PROJECT NAME
Alpine Street Garage

PROJECT ADDRESS
11-15 ALPINE STREET
SOMERVILLE, MA

REVISION TO ZBA 2016-75
September 16, 2021

List of Changes; Refer to Accompanying Narrative.

A-104

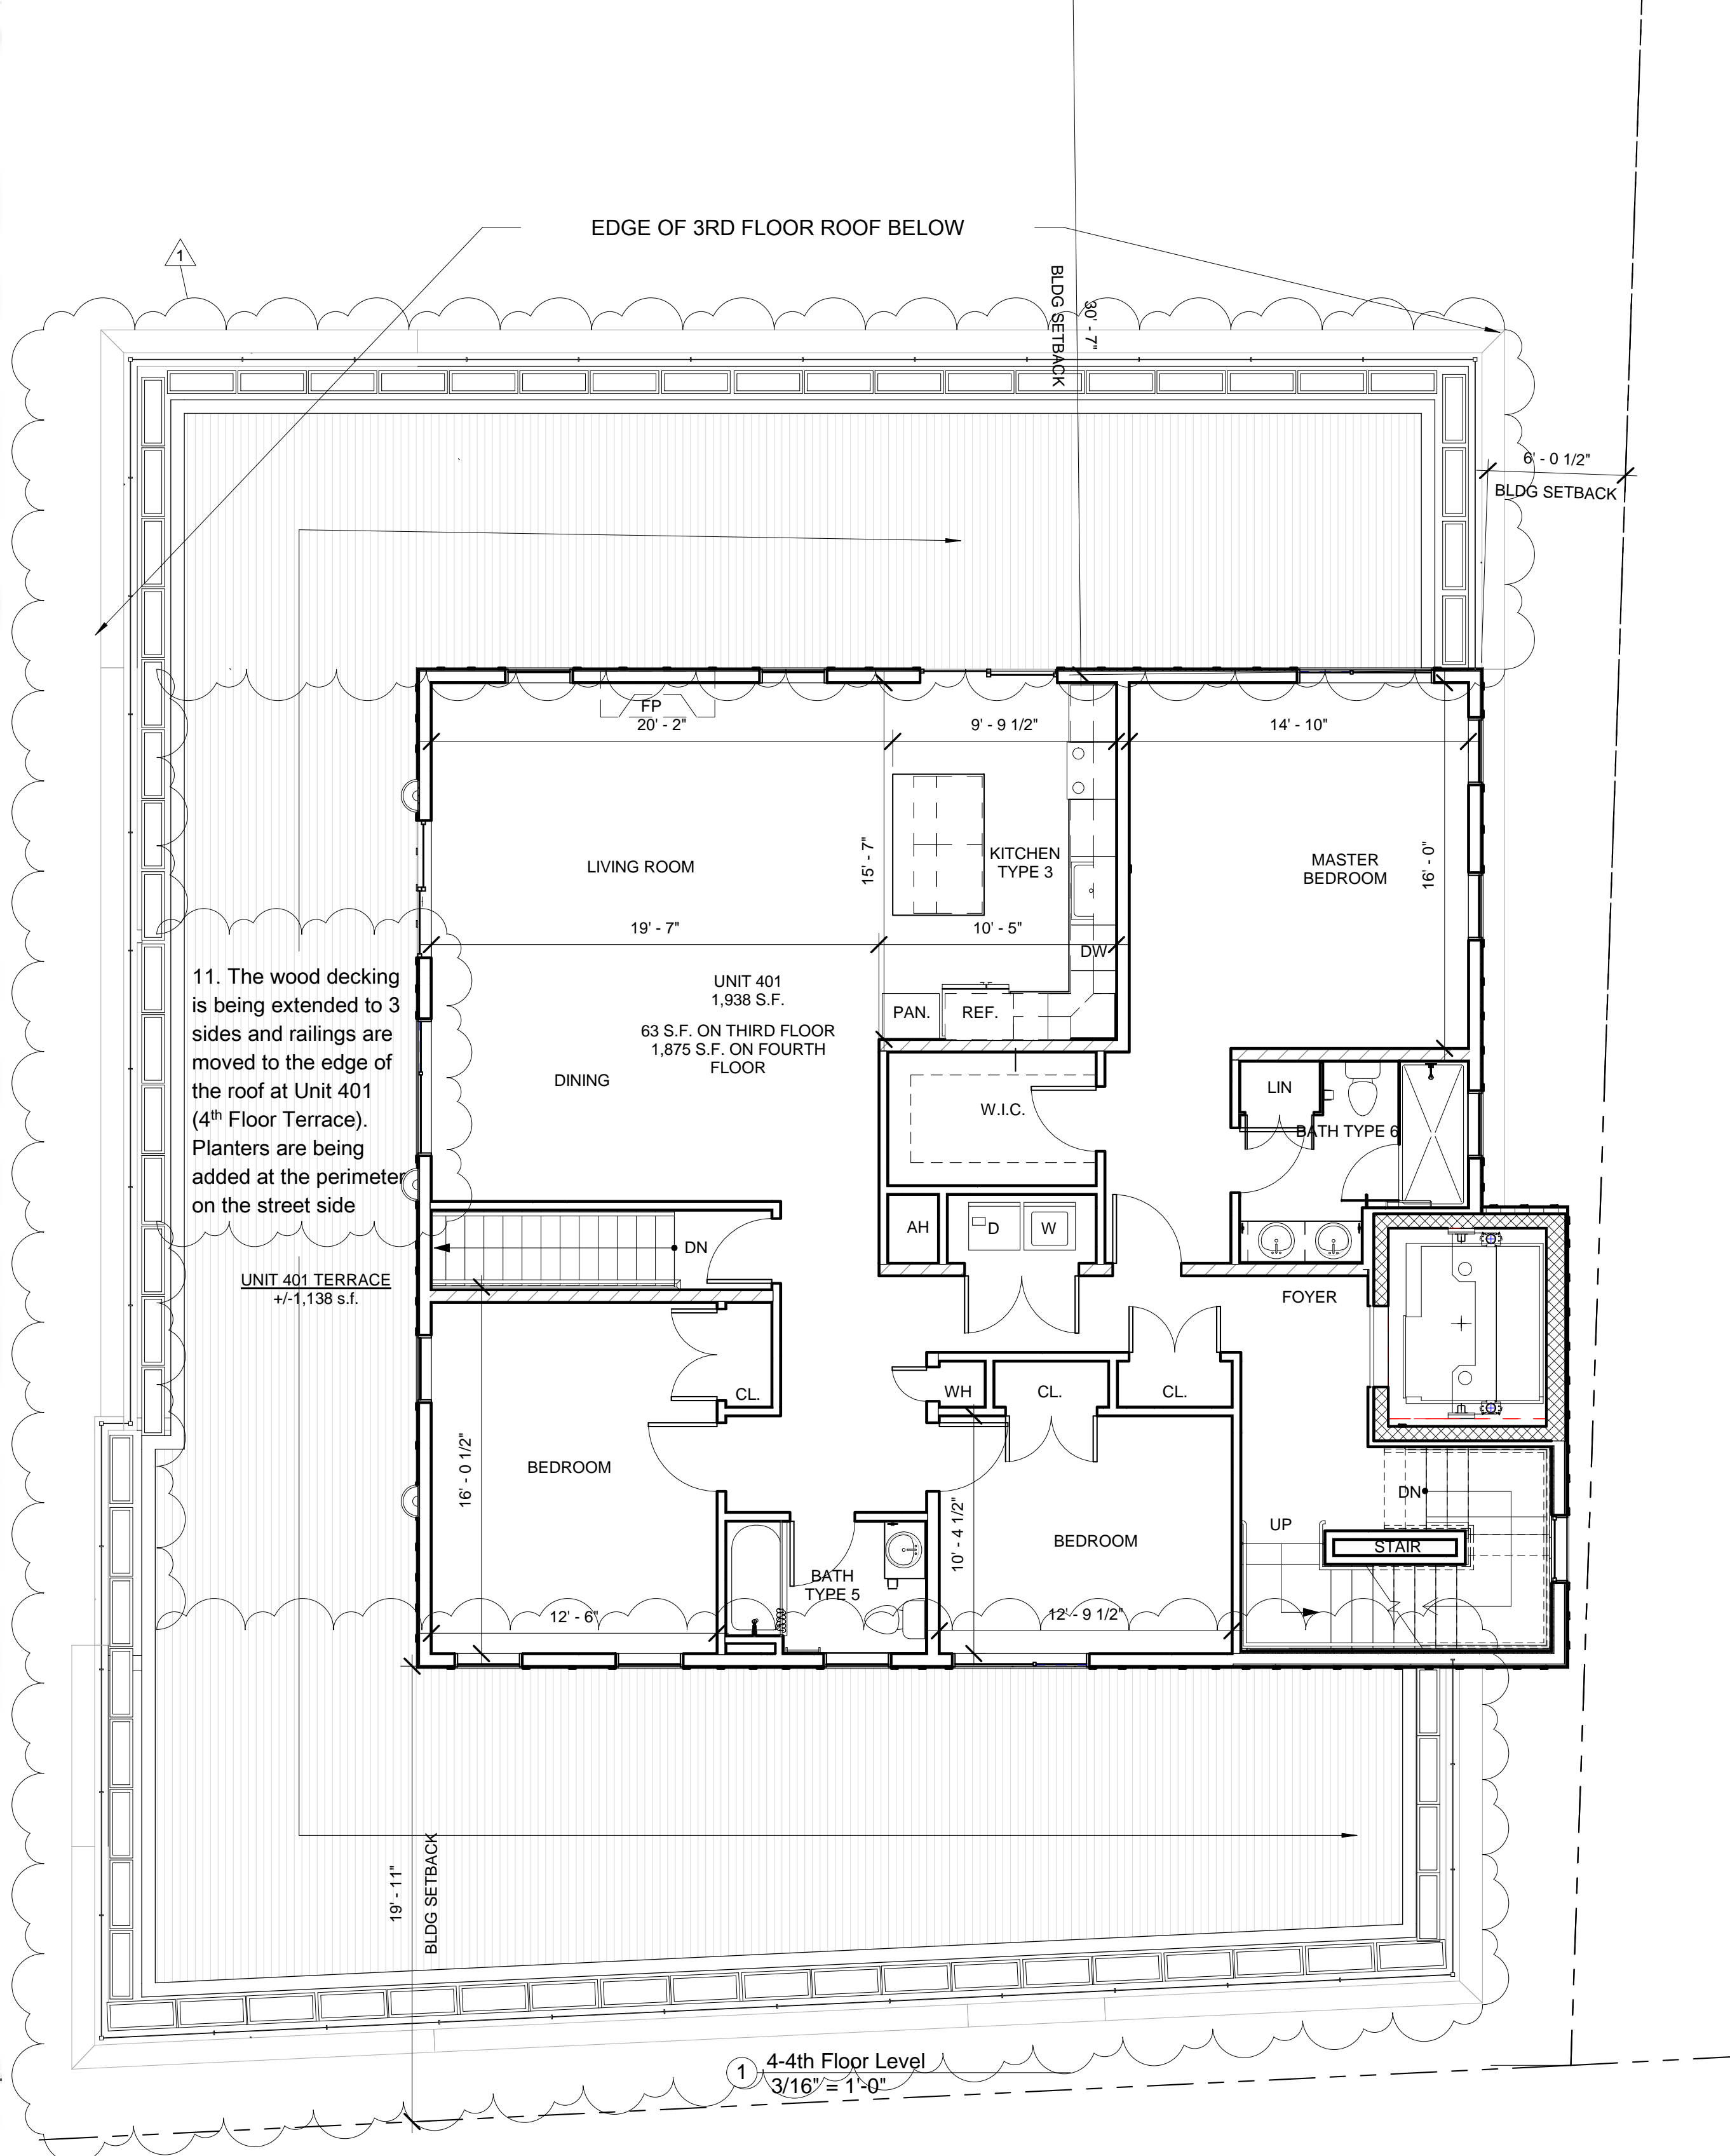
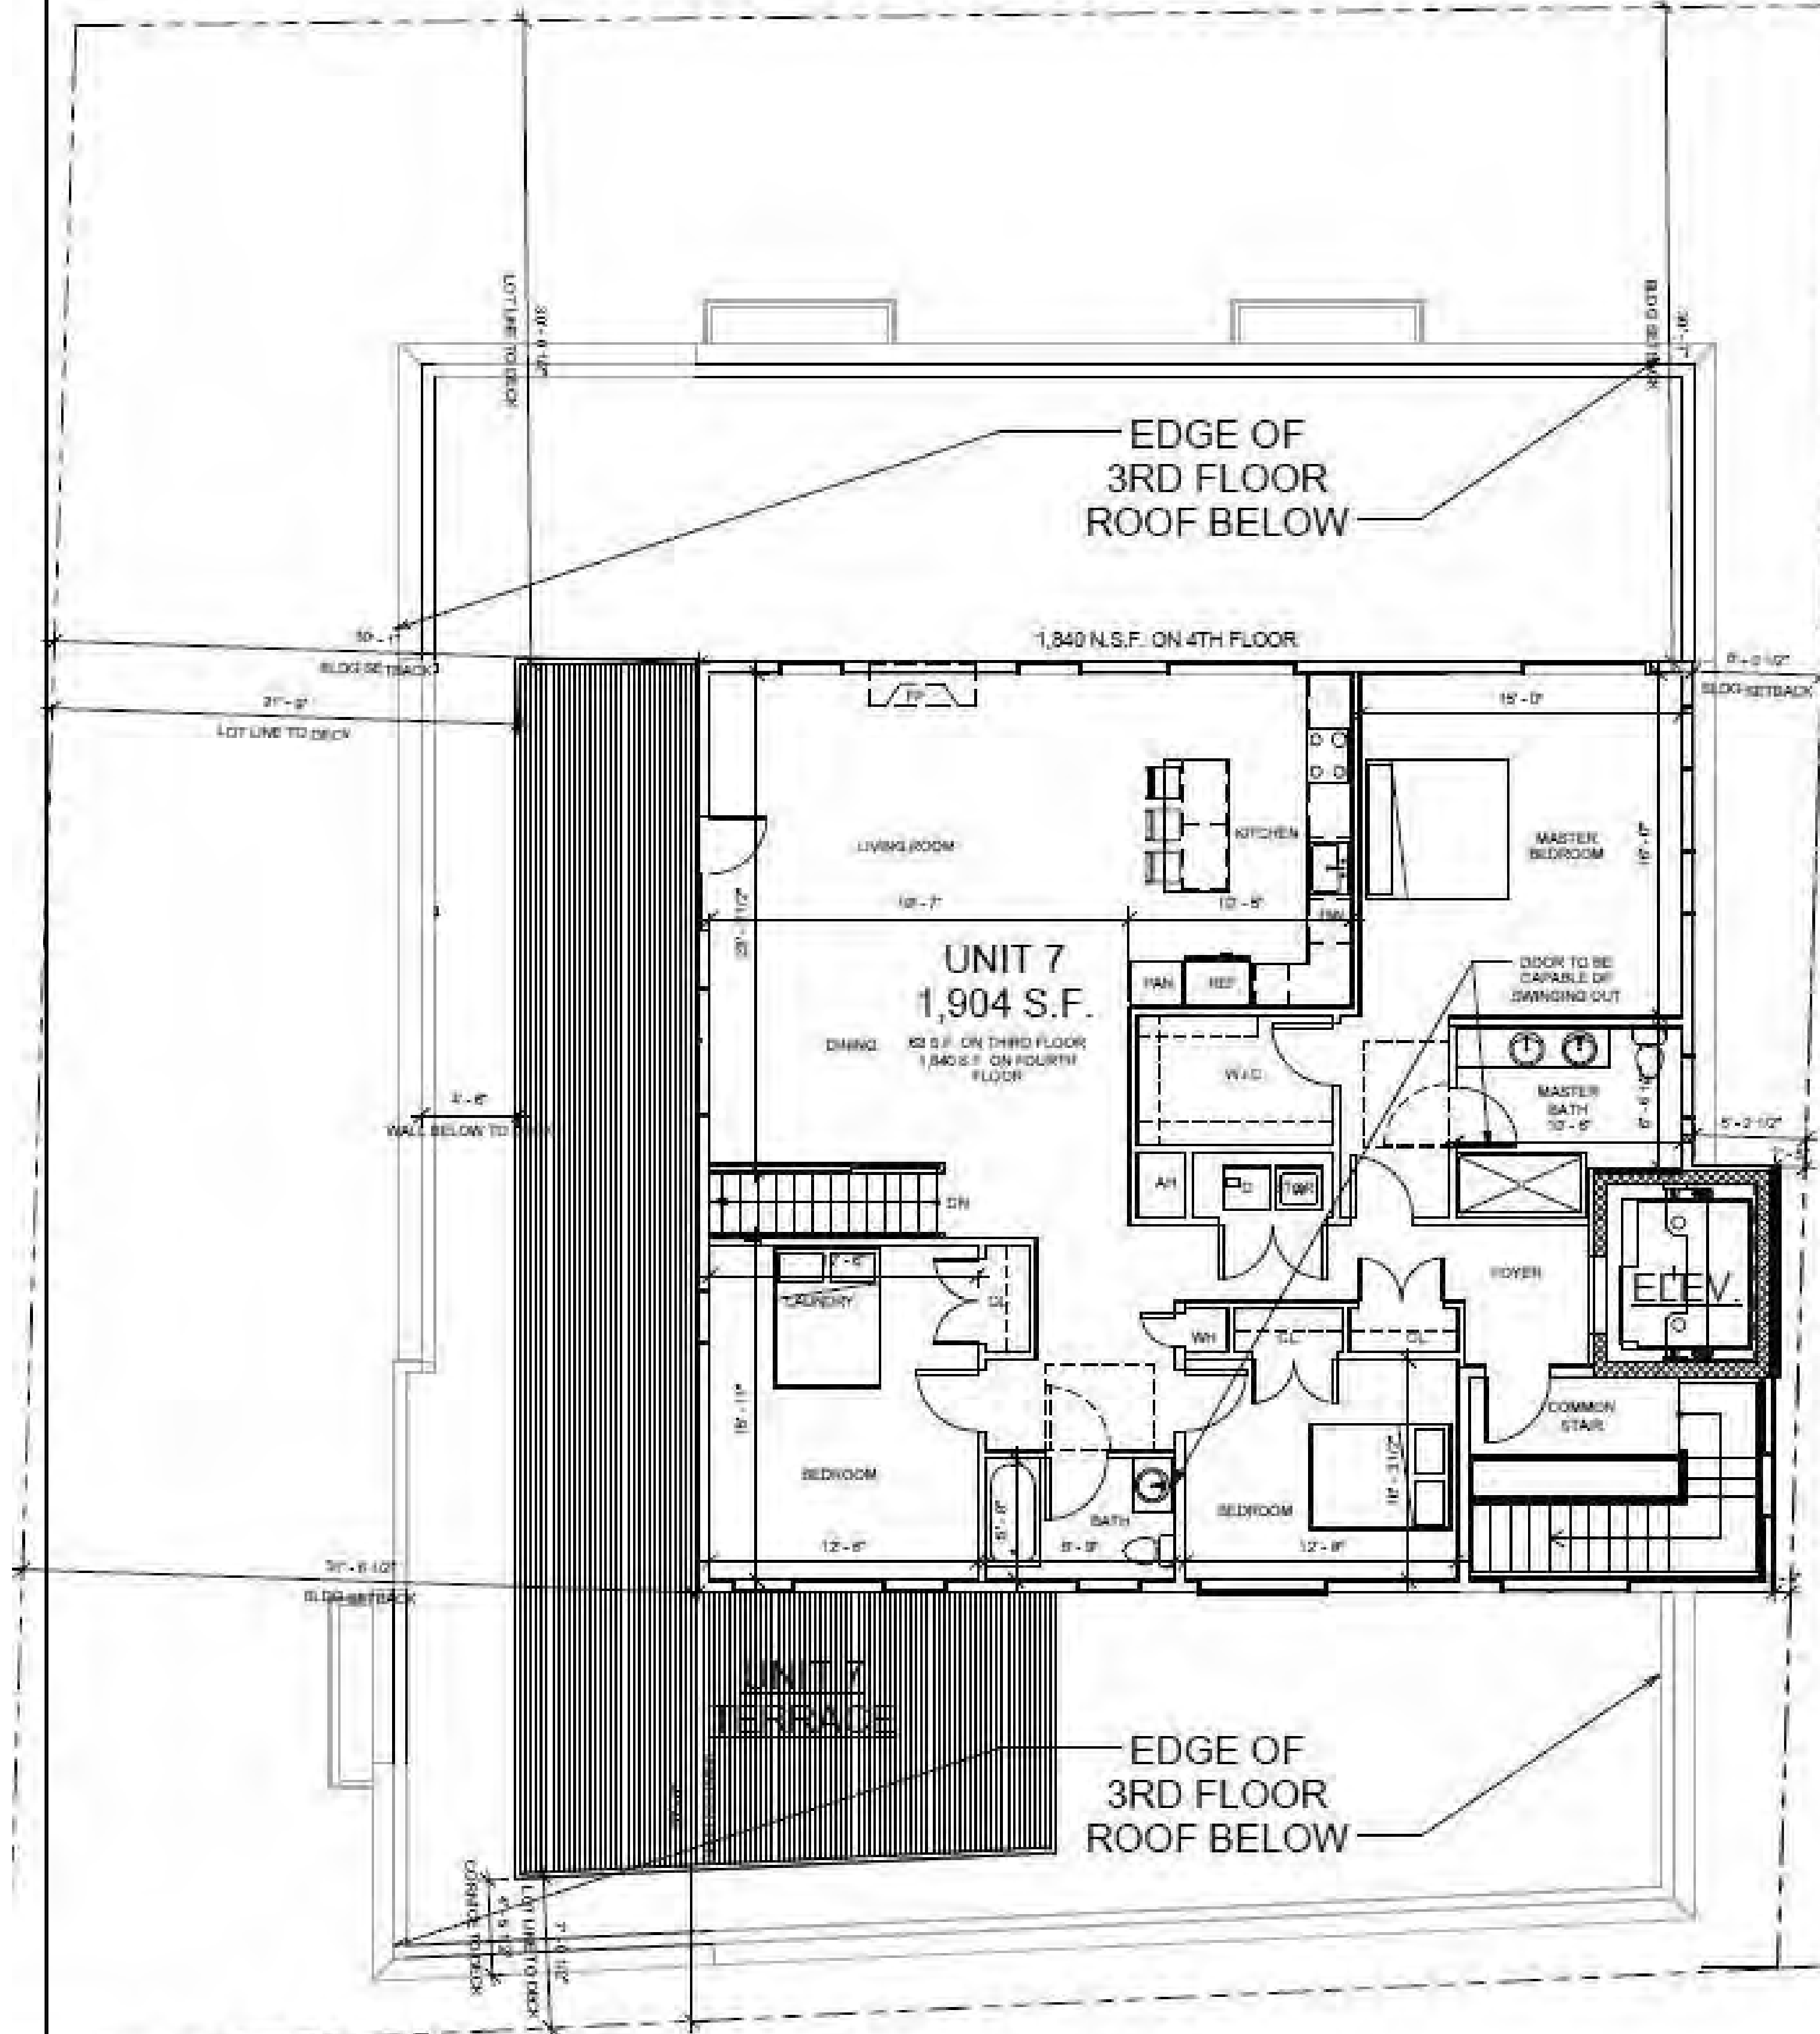
1. The right-side elevation staircase overrun on the roof, which is adjacent to the rooftop elevator overrun, has been extended to match the height of said adjacent elevator overrun.
2. The batten pattern at the top floor and right-side stair tower has been adjusted.
3. New cast stone signage at the center of the front façade is now proposed to read "13 Alpine Street".
4. The veneer at the front wall headers and columns is to be changed to cast stone (Arriscraft or Similar).
5. CMU block is to be used on the Easterly wall.
6. The door and window pattern at the front left side ground floor space has been altered as shown in the elevations.
7. The windows have been slightly altered on all facades as shown in the elevations.
8. The front wall has been replaced as shown in the elevations.
9. The iron railings are to be horizontal.

10. Cedar screening of the rooftop mechanicals with safety tie-offs are being proposed as shown.
11. The wood decking is being extended to three sides of Unit 401 on the 3rd floor roof (a/k/a the fourth floor deck), thereby creating a larger balcony. Additional planters and florals are being proposed to help create a bee habitat. Three options are being proposed:

- A. Mount the railing on top of the parapet wall and construct a raised planter at the inside of the railing, or
 - B. Place the railing inside of the parapet wall on the deck and place planters on the parapet wall up to railing height to address neighbor's privacy concerns, or

- C. Place railing inside of the parapet wall on the deck and place planters inside of the railings on the deck
12. Cast concrete planters at the front of the building on the ground floor are being proposed.

13. The size and spacing of the planters have been altered on all facades as shown.
14. The second floor deck at Unit 201 has been reduced in size.
15. The rooftop HVAC units have been located on the roof, near the roof edge.
